CONSTRUCTION CODES VARIANCE/MODIFICATION APPLICATION

Date: 26 February 2014

Attachment to Construction Modification Request

**Roosevelt High School
4301 13th Street, NW
Part of Square 2915
Part of Lot 0802**

Figure 2 – Roosevelt High School
Building Area Modifications

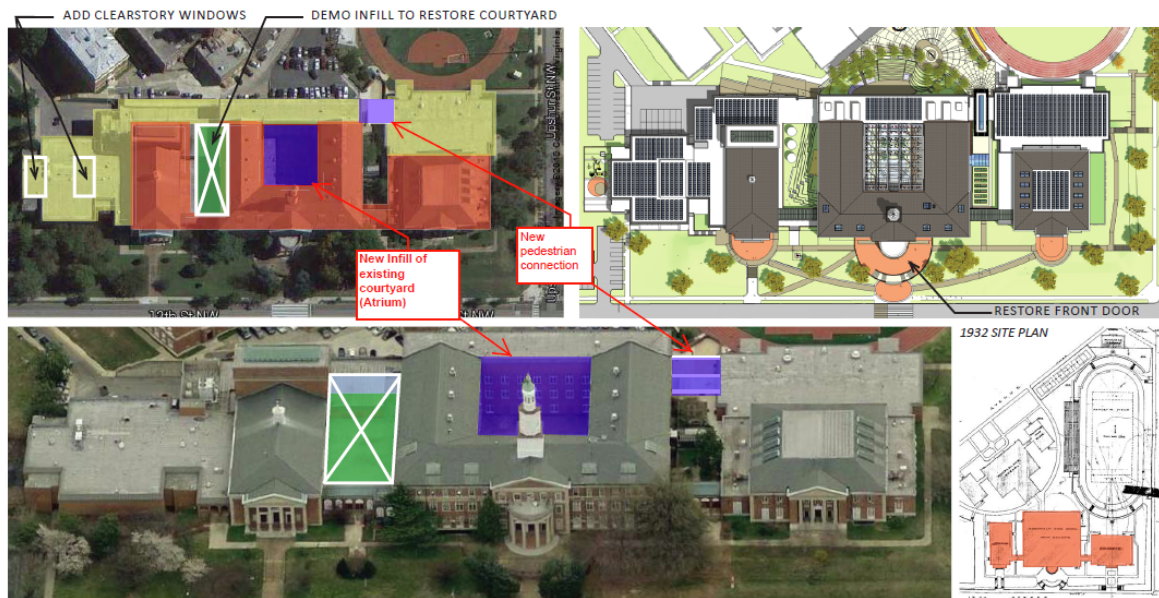
The inclusion of the new 3,000 square foot connector between the Academic Building and the Athletic Building and the enclosure of the Academic Building's existing courtyard creating an atrium both constitute *additions* per strict and literal application of the IEBC definition. Furthermore, site work around the perimeter of the existing Academic Building is such that the existing Ground Floor no

Considering the entire 331,900 square foot Roosevelt High School building as one building, without firewall separation, of Type IIB construction is a condition that would not comply with current codes. Furthermore, inclusion of the new courtyard and pedestrian connection floor areas would violate the conditions of IEBC Section 1102.2.

All new work to be of type IIA construction maintaining the model of the 1970's expansion work.
